SR 525

MUKILTEO FERRY TERMINAL (PHASE 2) FERRY TERMINAL CONSTRUCTION

VOLUME 1 SHEET INDEX

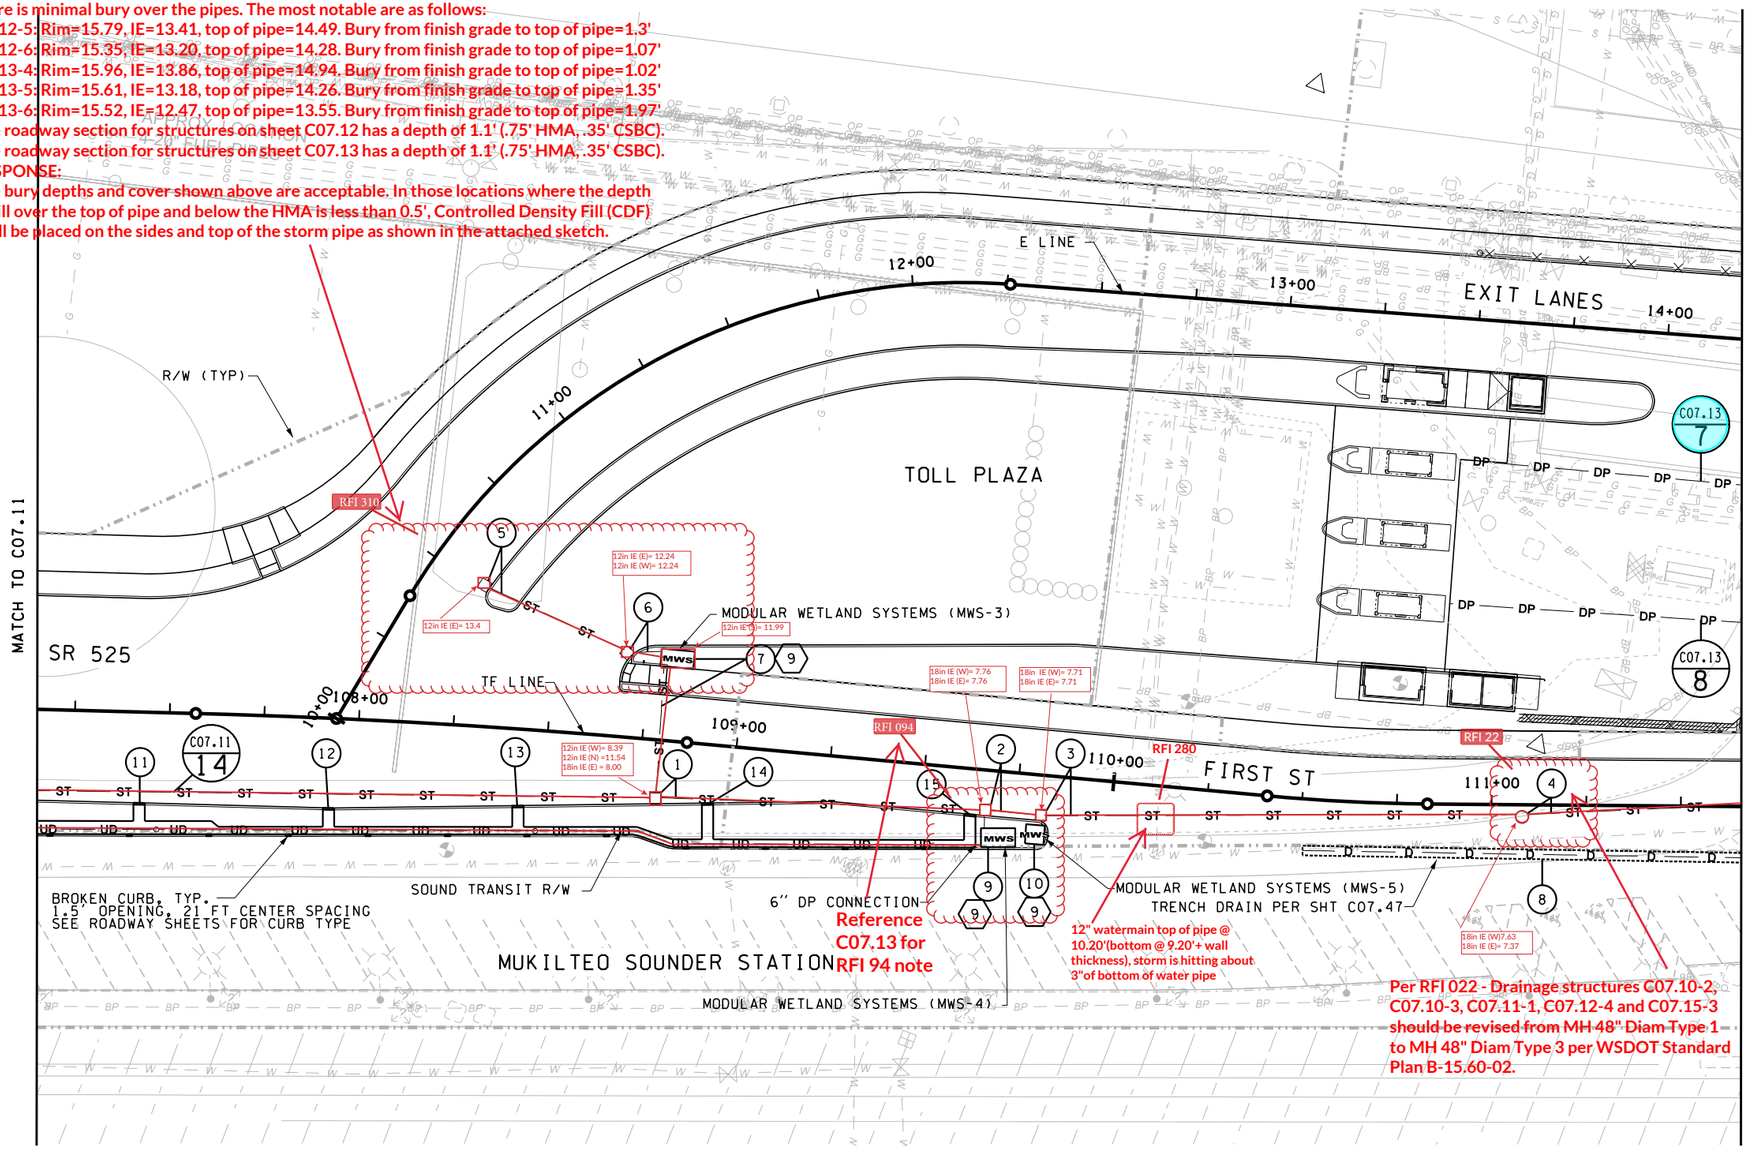
RESPONSE:
The bury depths and cover shown above are acceptable. In those locations where the depth of fill over the top of pipe and below the HMA is less than 0.5', Controlled Density Fill (CDF) shall be placed on the sides and top of the storm pipe as shown in the attached sketch.
